**Board of Adjustment Meeting Agenda
Thursday, July 10, 2008
7:00 p.m.
City Council Chambers**

Re: **B.A. 03-2008 911 Wellesley Place (Jim and Sandy McKeever)**: A request for variance from City of Chesterfield Ordinance 616 to allow an existing residence located at the referenced address in the Wellesley Place Subdivision to maintain an 11 ft. rear yard setback in lieu of the required 15 ft. rear yard setback. (18S630460)

Jim and Sandy McKeever, the owners of the above-referenced single family home, have submitted a request to the Board of Adjustment for the above-mentioned variance. In review of the petitioners' request, the Department of Planning submits the following report.

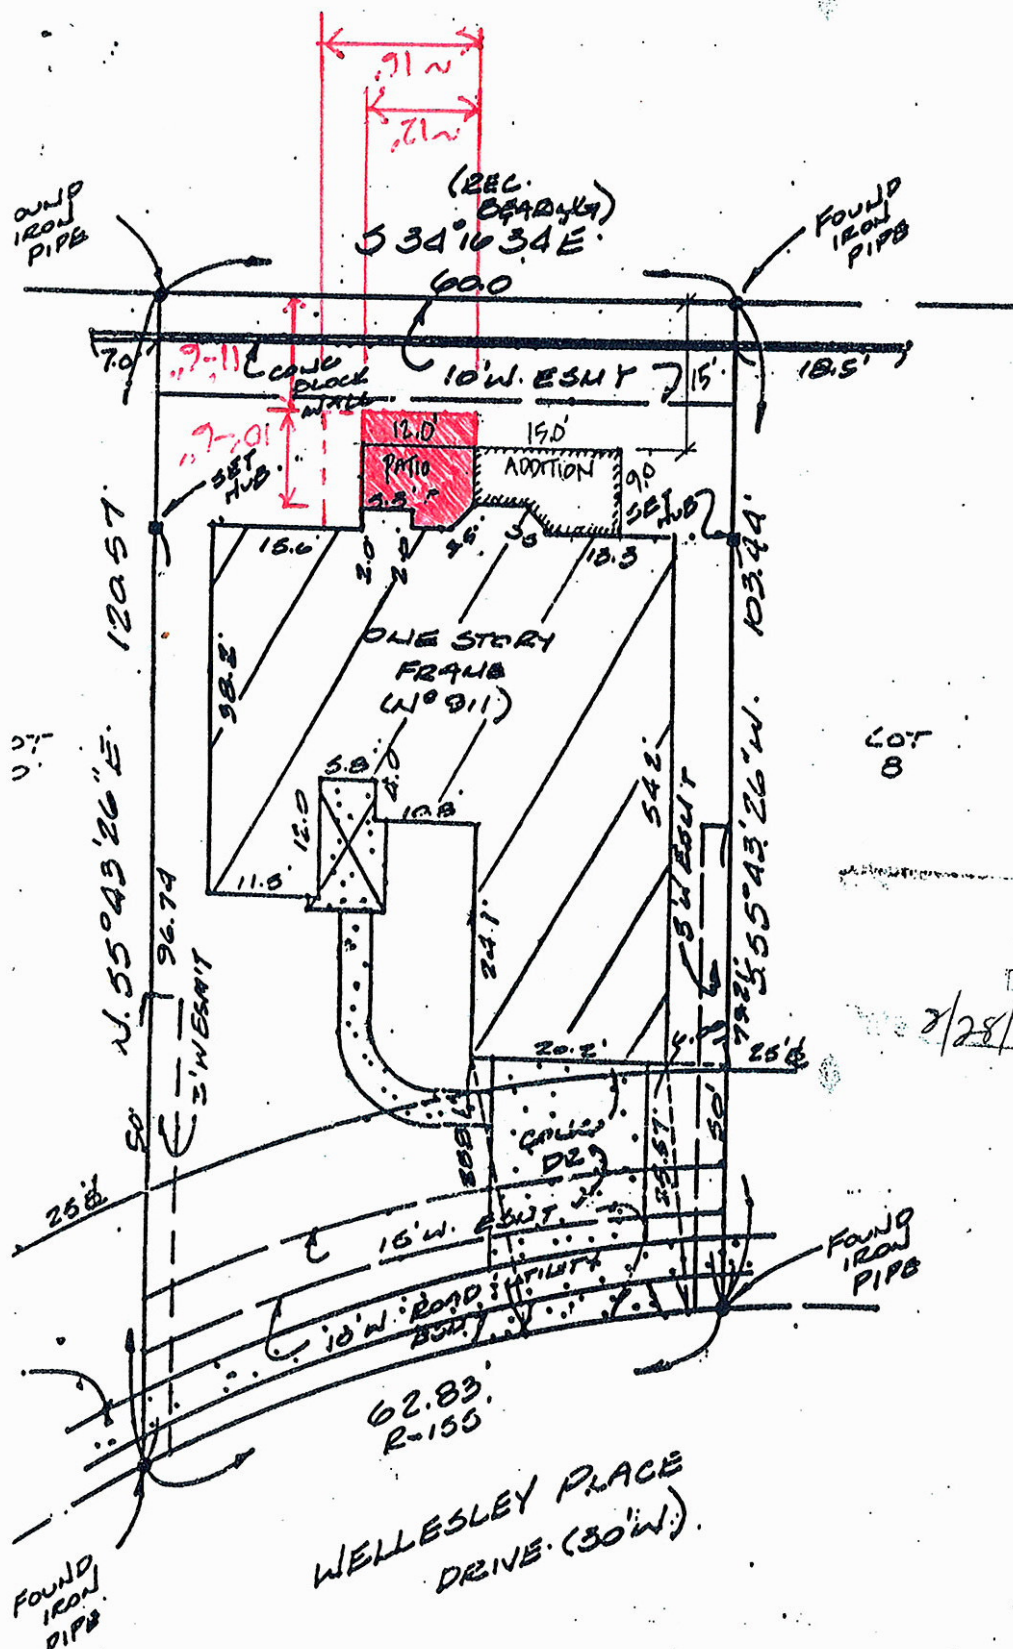
Thank you for providing a plot plan with your verbal request for approval by the Trustees for a screened-in patio at the back of your house. Please be advised that the Board of Trustees grants architectural approval only.

You provided a plot plan and a brief verbal description of "a screened-in porch" but you did not specify the finish materials of construction or color. Presumably, the screen support structure will be finished to match the existing siding and trim. Please advise the Board if this is not the case.

The plot plan shows the patio extends 12'-6" from the foundation of the house and this leaves 11'-6" to the back property line. Please be advised that the City of Chesterfield requires a fifteen (15)-foot rear yard setback in an "R4" (PEU) District. You must request a variance from the City.

It appears that the patio is being extended (sideways) to meet the 1997 addition although this change is not shown on the marked-up plot plan. You told me that the roof of the screened in patio will "match" the existing roof on the addition. The patio is being extended to the rear beyond the 1997 addition but it is not clear whether the slope of the patio roof will match the slope of the roof on the addition. It would be preferable, aesthetically, to have a single roof over both structures. Please advise the Board if this is not the case.

The additional structure will add to run-off from your property. What provisions are being made about drainage? Please contact MSD to confirm that they approve of the change.

This letter grants you conditional approval pending confirmation of the finish materials and color(s) and confirmation of the roofline. This letter should be sufficient for you to request zoning approval from the City. Once you have final building plans, please forward a copy to me for the subdivision records and for final architectural approval.
